ADDENDUM NO. 03

Date: 09.19.2025

Project: Sheridan HS and MS School Renovation Project

The Hagerman, Inc portion of this Addendum consists of the following information:

DRAWING NUMBER
ED201A

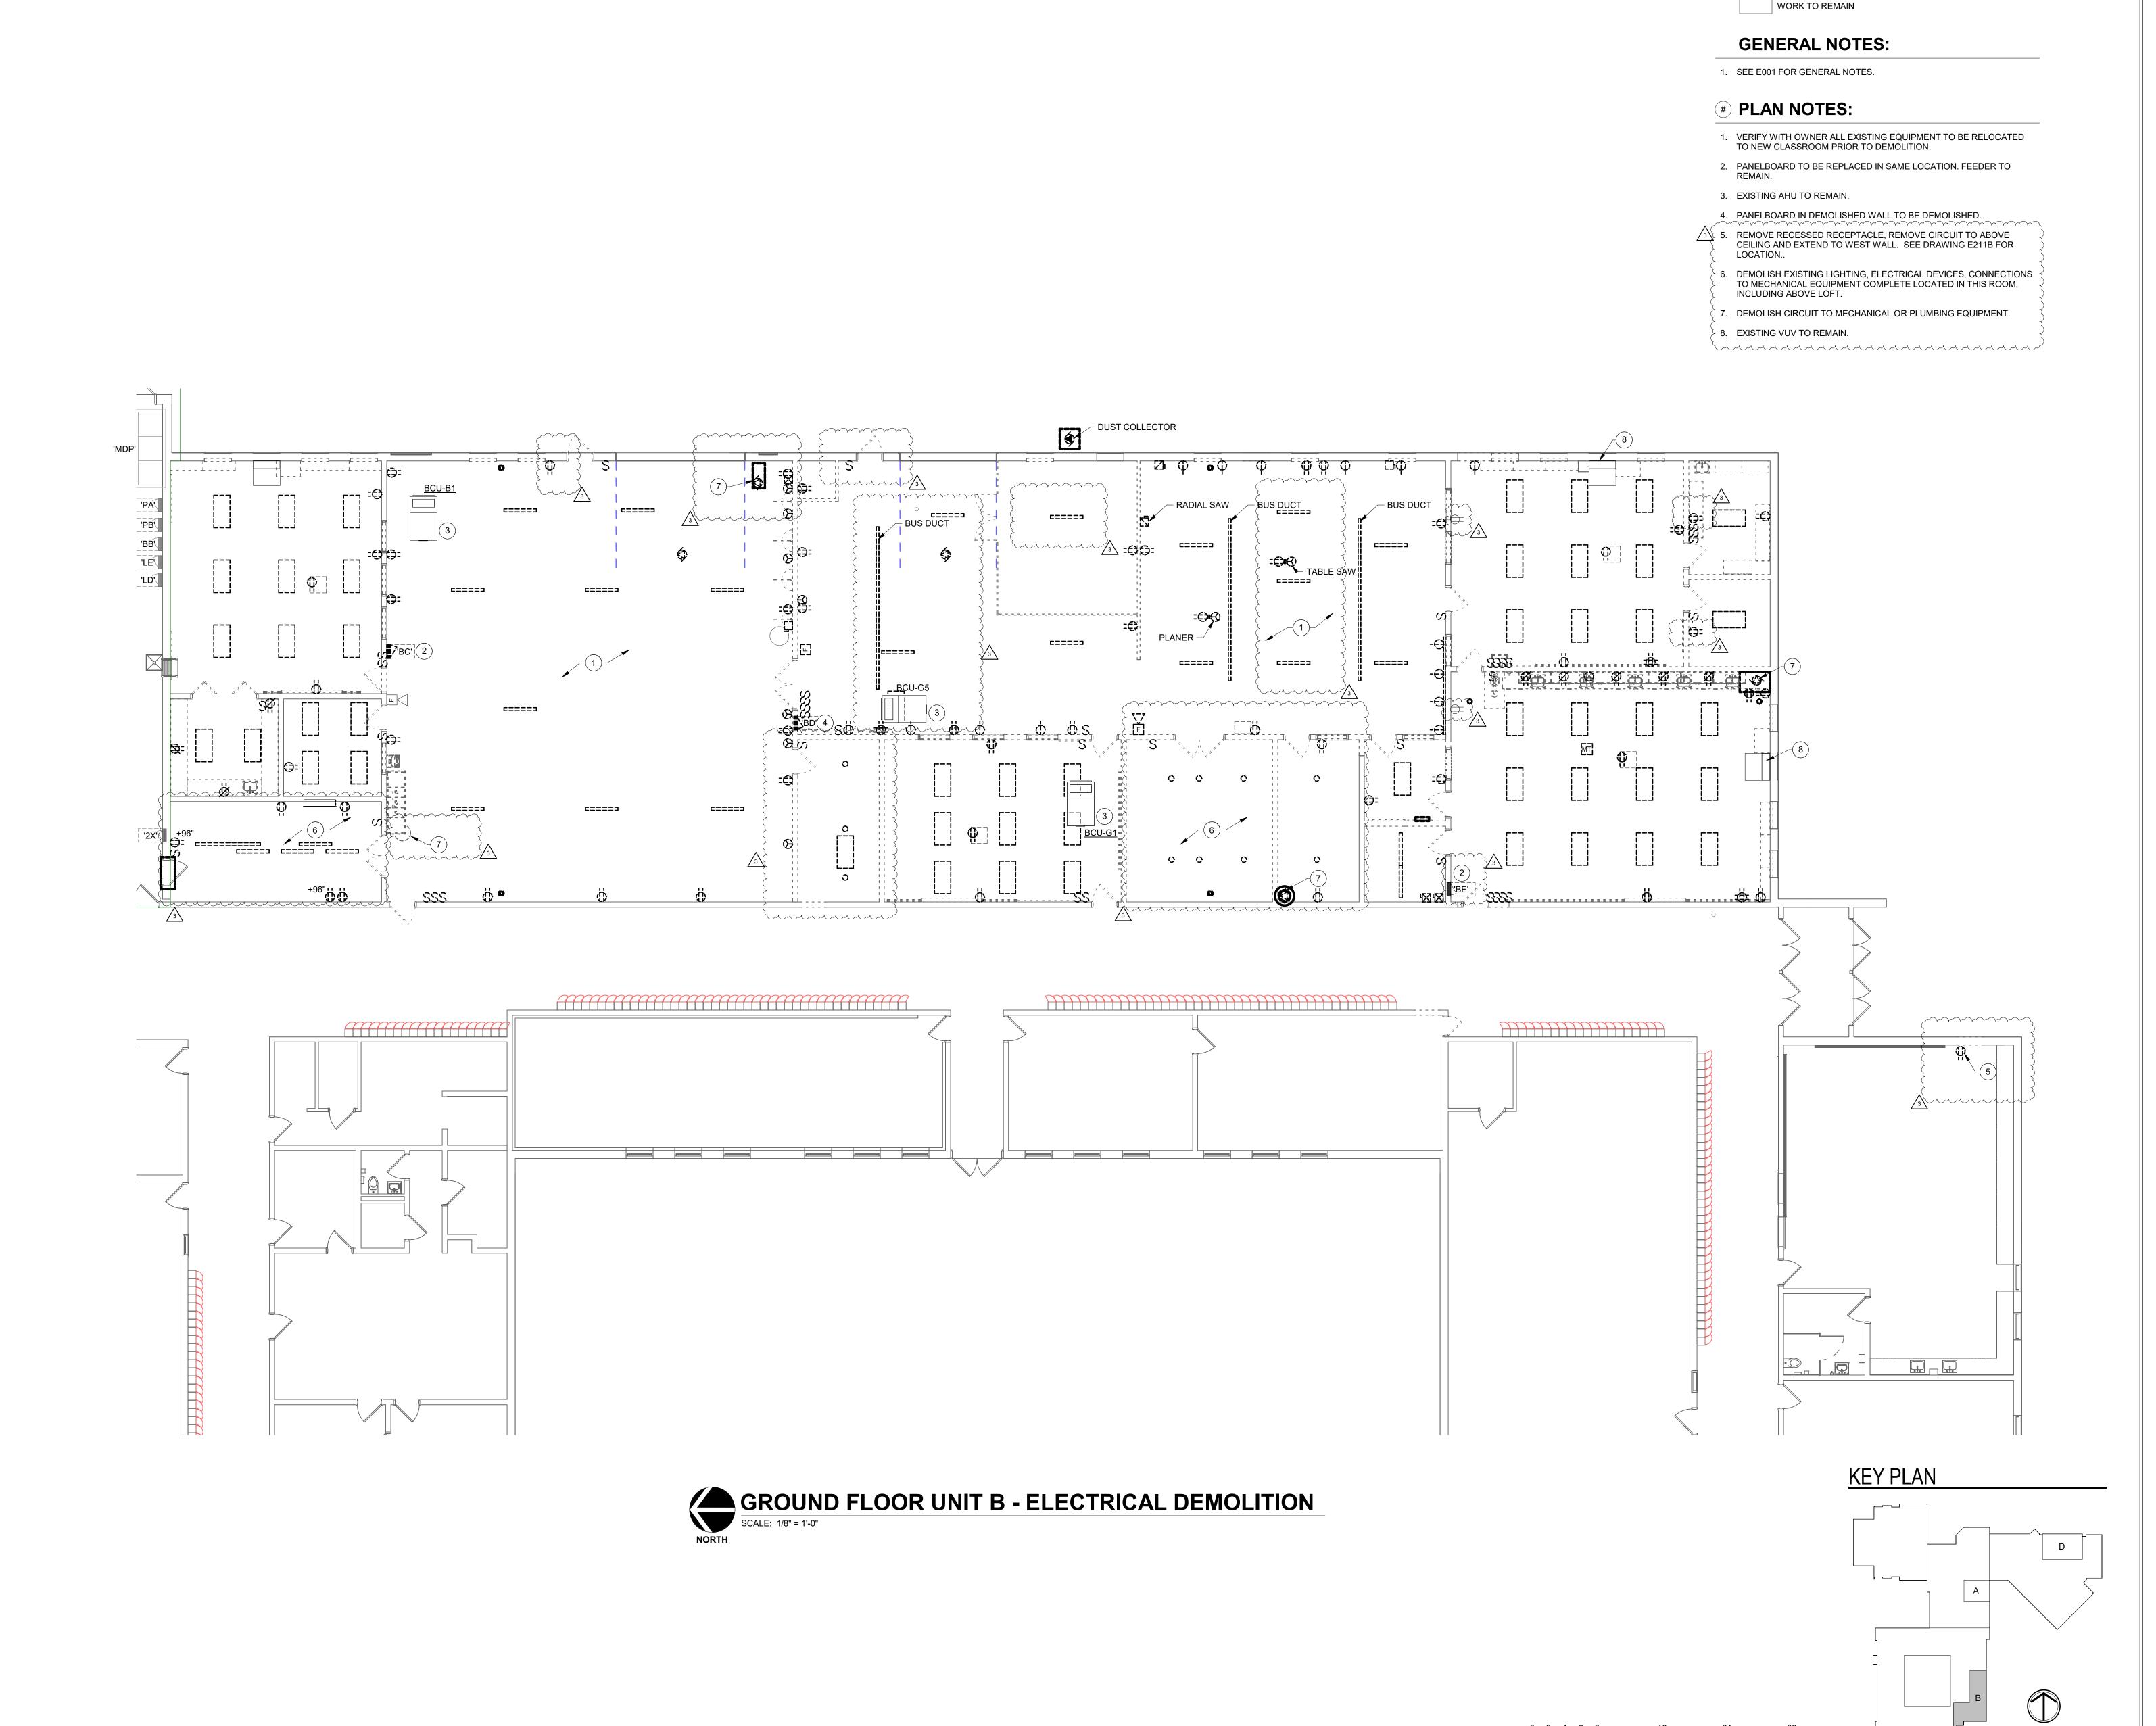
- 33.Bid Item #13 Mechanical Contractor shall review and be responsible for all controls and notes per the new Drawing M702.
- 34.Bid Item #14 Electrical Contractor shall be responsible for Plan Notes 3, 4, 5, 6, 7, 8, 9, and 10 on Drawing ED201A.

TD201B

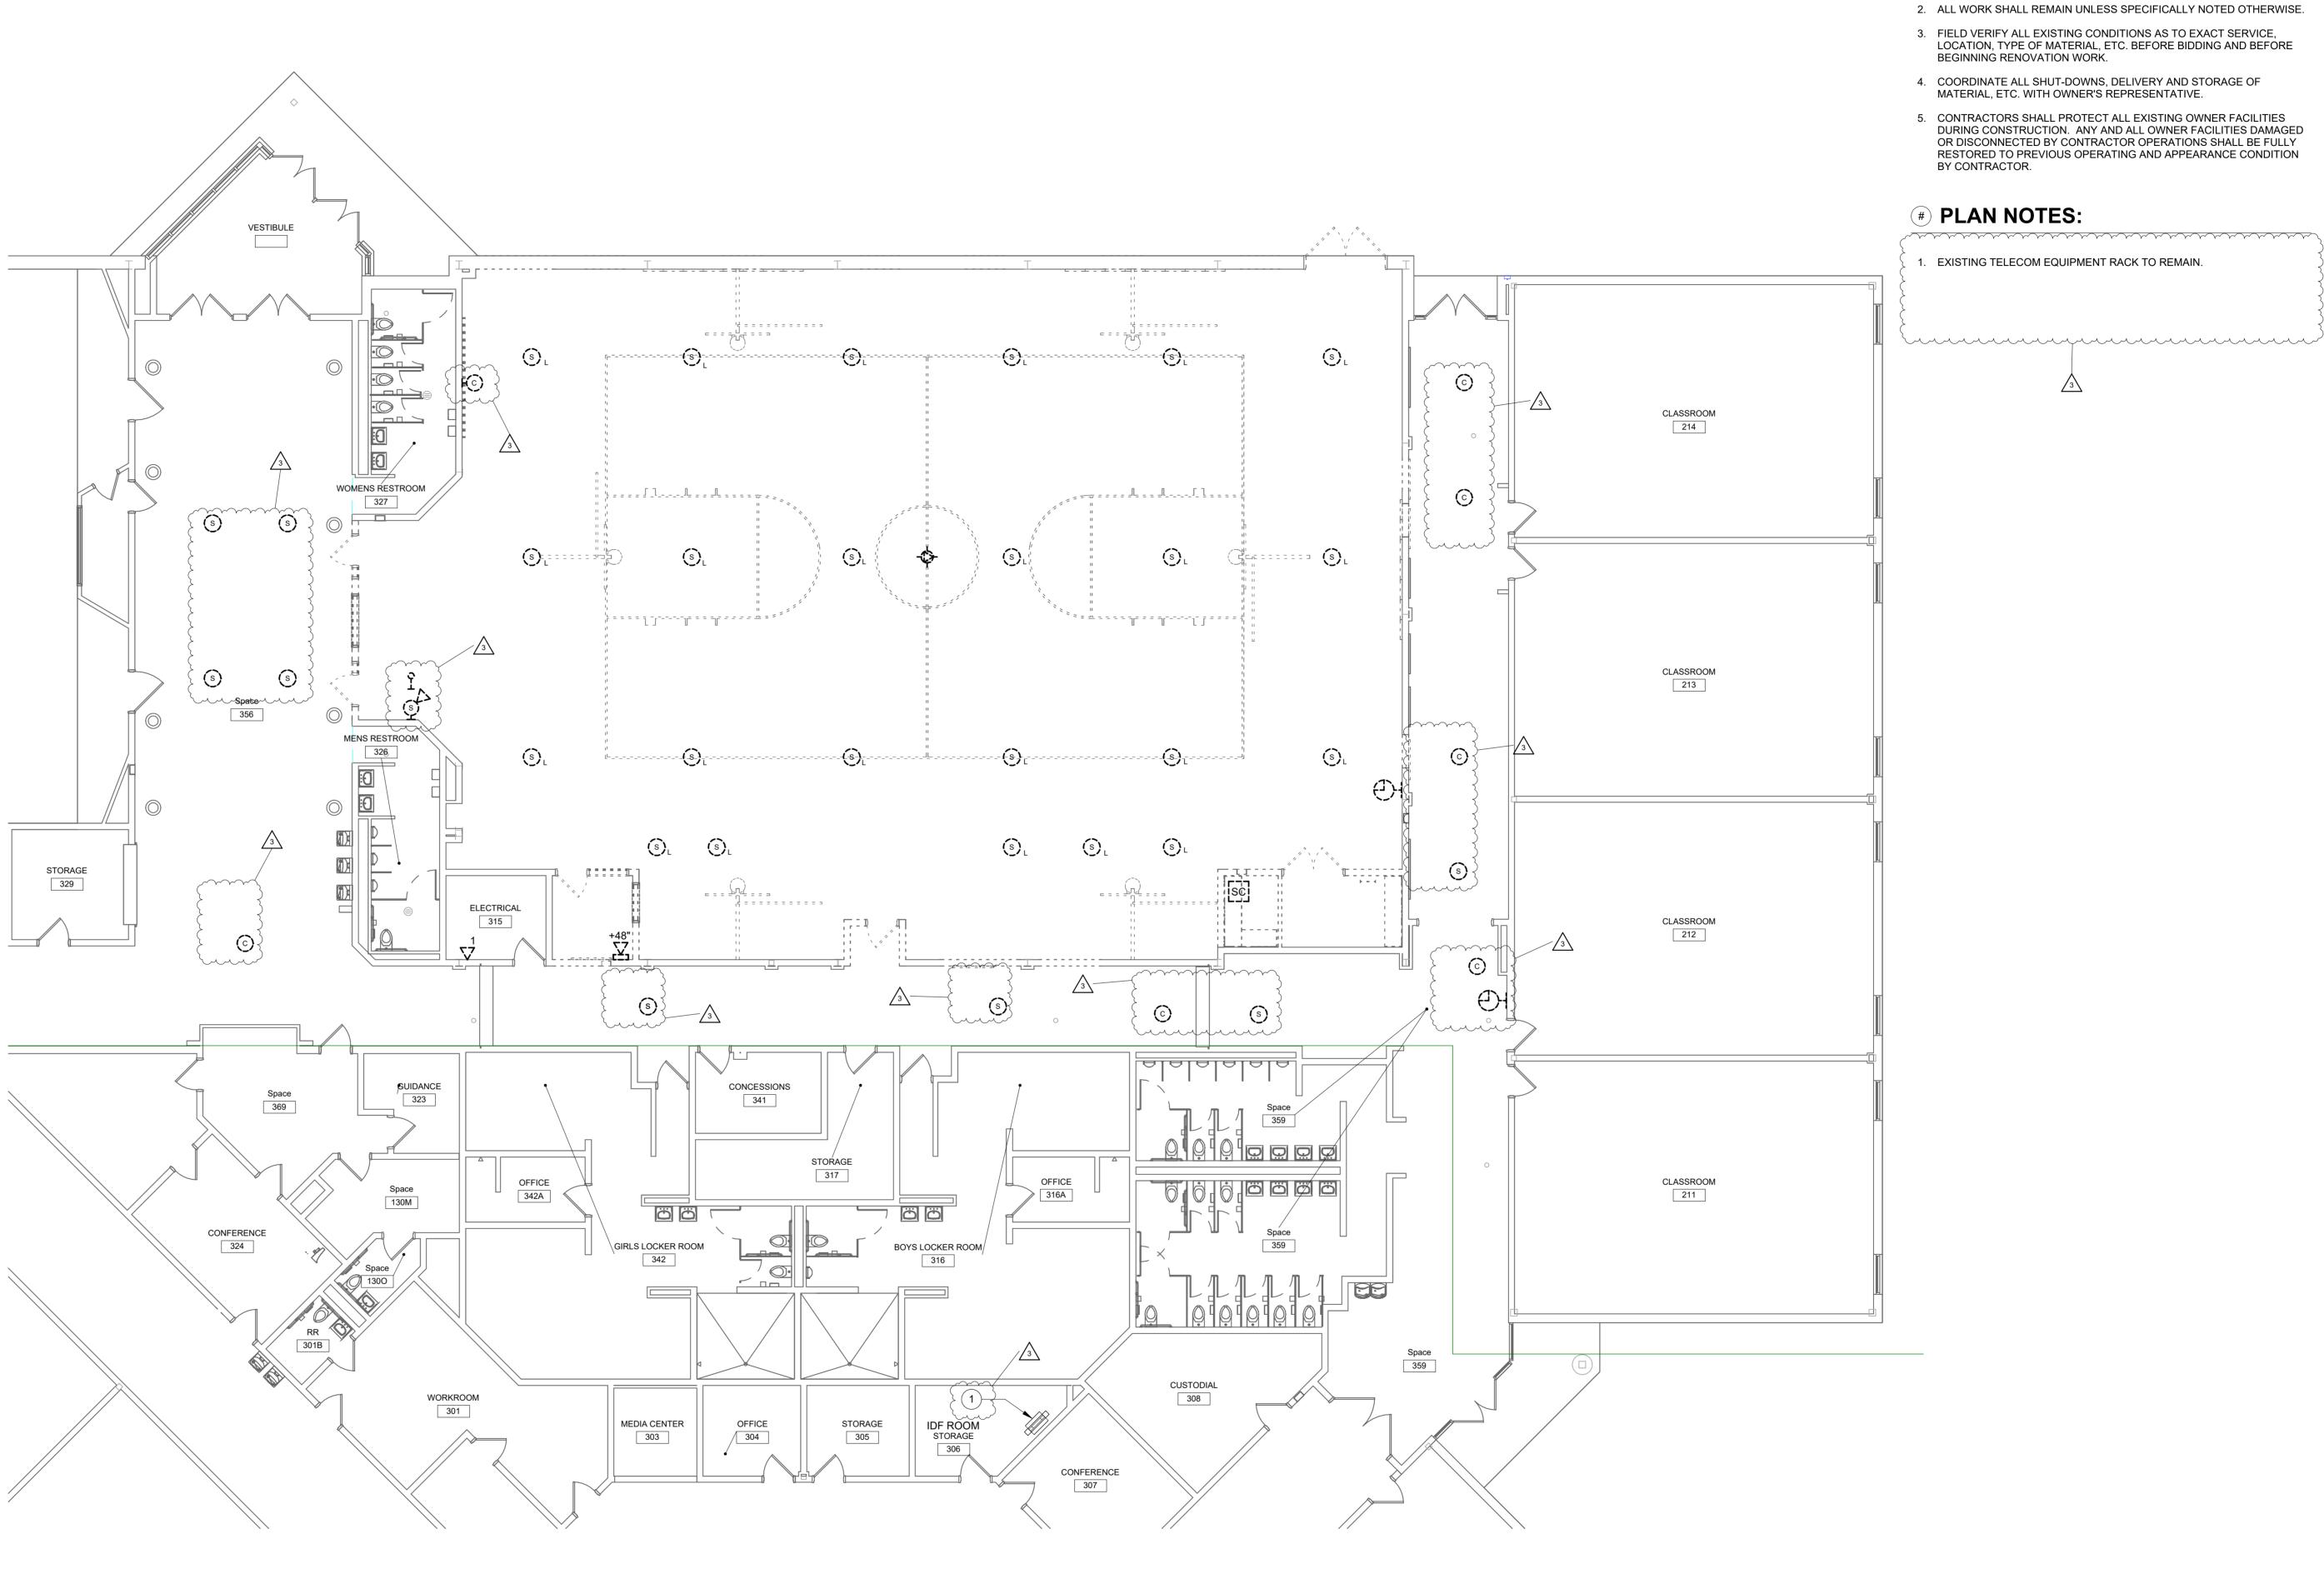
- 41.Bid Item #14 Electrical Contractor shall review revised Plan Note 1 on Drawing TD201B. Refer to section 00 25 00 for photo of existing telecom equipment.
